Notice of Modification

The Development Consent for the Hay Solar Project (SSD 8113) granted by then the Executive Director, Resource Assessments and Business Systems as delegate of the Minister for Planning, on 20 December 2017.

Hay Sun Farm modification
Figure 4.1

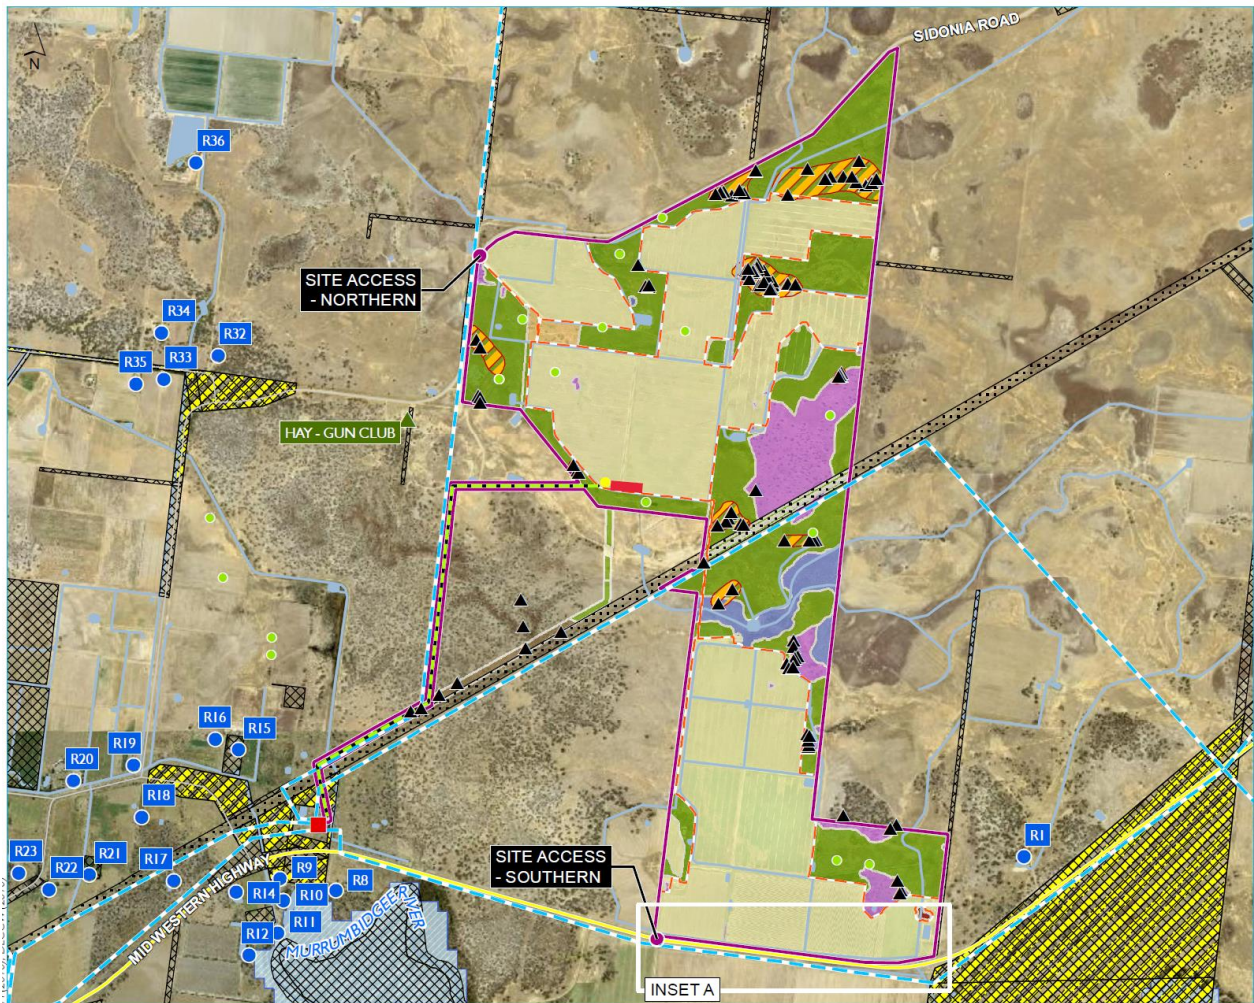
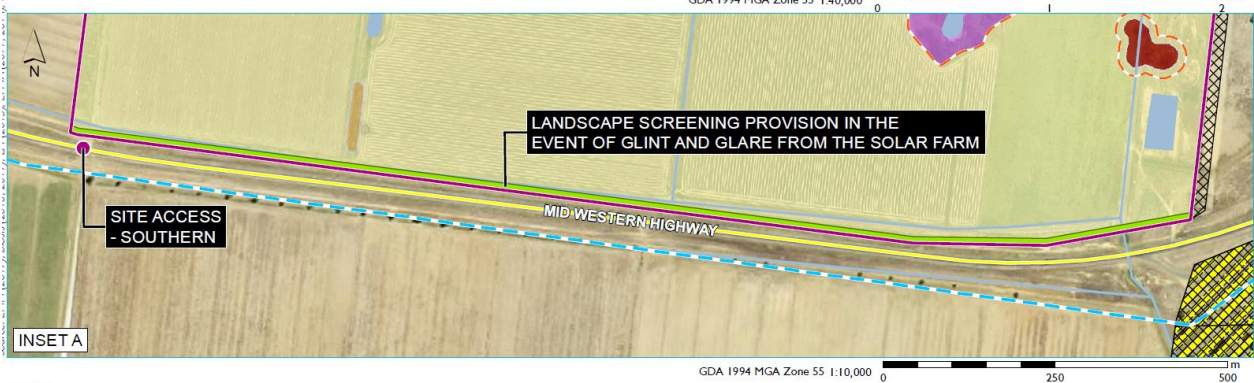
- (a) "of the southern portion and the use of the southern access point (shown in Appendix 1)";

- (b) prior to the commencement of construction of the northern portion and use of the northern access point (shown in Appendix 1):
 - upgrade the intersection of Sidonia Road and the site entry point to provide a Basic Right Turn (BAR) treatment and a Basic Left Turn (BAL) treatment, to the satisfaction of Hay Shire Council, in accordance with the *Austroads Guide to Road Design* (as amended by RMS supplements), unless the relevant road authority agrees otherwise; and
 - restore any damage to Sidonia Road and the road reserve during construction and completion of road construction, to the satisfaction of Council.

8. Delete Appendix 1 and insert the following:
